CLIMATE
ACTION
RESERVE

Nitric Acid Production Project Protocol Version 1.0 ERRATA AND CLARIFICATIONS

3. Figure 4.1 (ERRATUM – March 17, 2011)

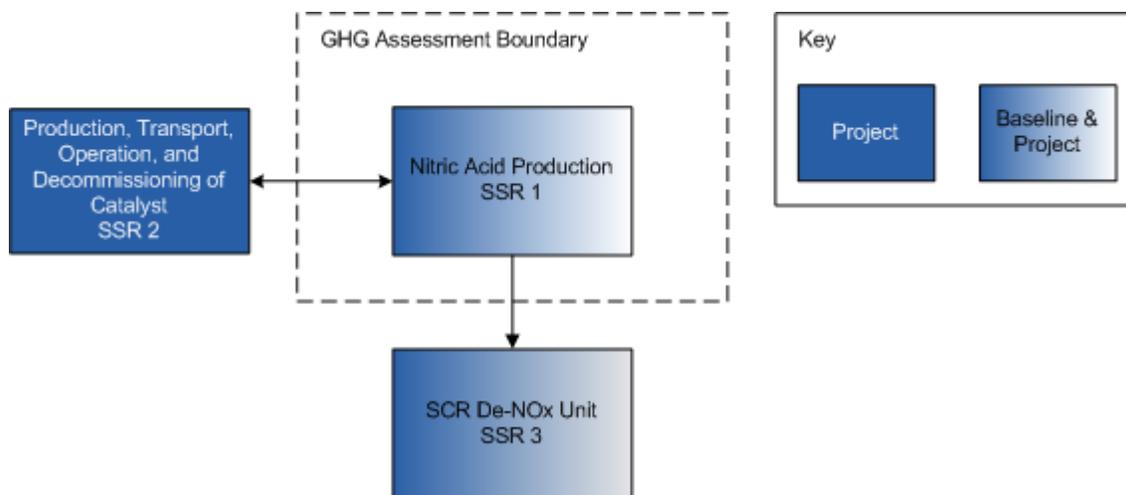
Context: Figure 4.1 provides a general illustration of the GHG Assessment Boundary for secondary catalyst projects, indicating which SSRs are included or excluded from the boundary. It includes SSR 3 – SCR De-NO_x Unit within the boundary, while the corresponding Table 4.1 correctly excludes SSR 3 from the boundary.

Correction: SSR 3 – SCR De-NO_x Unit was erroneously included within the boundary in Figure 4.1. SSR 3 should be excluded from the GHG Assessment Boundary in Figure 4.1, making it consistent with Table 4.1. The effect of SCR de-NO_x technology on N₂O emissions is not only small, but also equivalent in the baseline and project. The corrected Figure 4.1 appears below.

4. Figure 4.2 (ERRATUM – March 17, 2011)

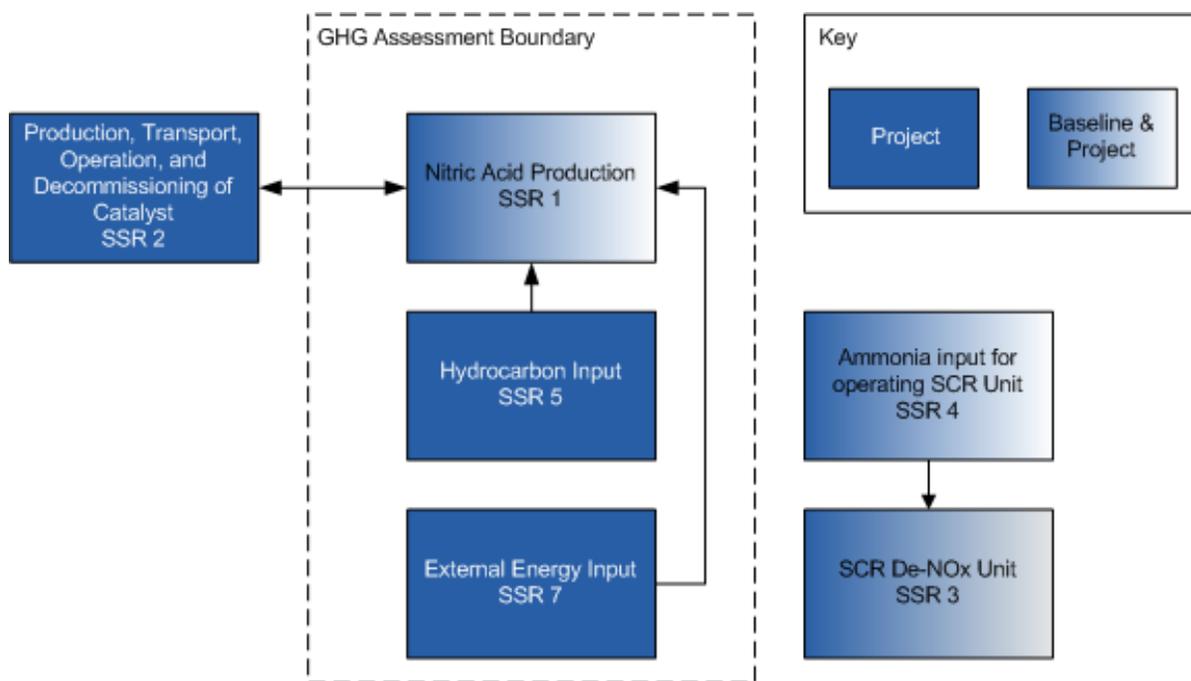
Context: Figure 4.2 provides an illustration of the GHG Assessment Boundary for tertiary catalyst projects with existing SCR De-NO_x units operating prior to the project start date, indicating which SSRs are included or excluded from the boundary. It includes SSR 3 – SCR De-NO_x Unit within the boundary, while the corresponding Table 4.2 correctly excludes SSR 3 from the boundary.

Correction: SSR 3 – SCR De-NO_x Unit was erroneously included within the boundary in Figure 4.2. SSR 3 should be excluded from the GHG Assessment Boundary in Figure 4.2, making it consistent with Table 4.2. The effect of SCR de-NO_x technology on N₂O emissions is not only small, but also equivalent in the baseline and project. The corrected Figure 4.2 appears below.

5. Figure 4.3 (ERRATUM – March 17, 2011)

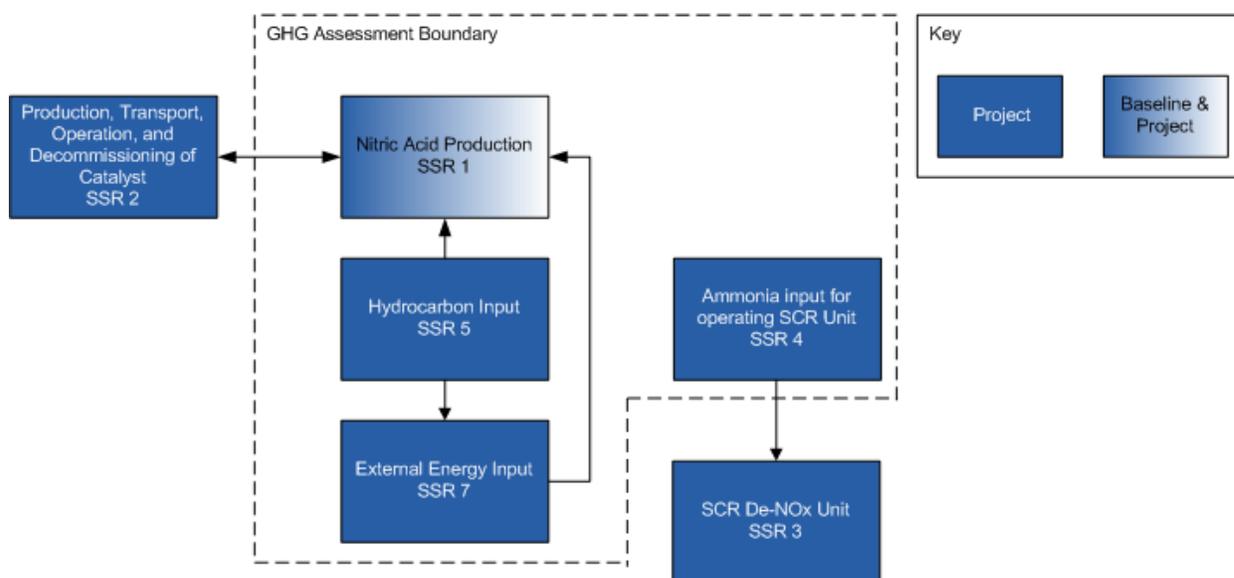
Context: Figure 4.3 provides an illustration of the GHG Assessment Boundary for tertiary catalyst projects without existing SCR De-NOx units operating prior to the project start date, indicating which SSRs are included or excluded from the boundary. It includes SSR 3 – SCR De-NOx Unit within the boundary, while the corresponding Table 4.2 correctly excludes SSR 3 from the boundary. The effect of SCR de-NOx technology on N₂O emissions is assumed to be minimal and therefore not necessary to include. Additionally, SSR 3 and SSR 4 – Ammonia Input for operating SCR Unit are both erroneously shaded to indicate emissions are relevant in both the baseline and the project.

Correction: SSR 3 – SCR De-NOx Unit was erroneously included within the boundary in Figure 4.3. SSR 3 should be excluded from the GHG Assessment Boundary in Figure 4.3, making it consistent with Table 4.2. In addition, SSR 3 and SSR 4 should both be colored solid blue, to indicate that emissions from these sources are only relevant in the project. The SCR de-NOx unit and the ammonia used to operate it are added in conjunction with the tertiary catalyst, and are therefore not present in the baseline. The corrected Figure 4.3 appears below.
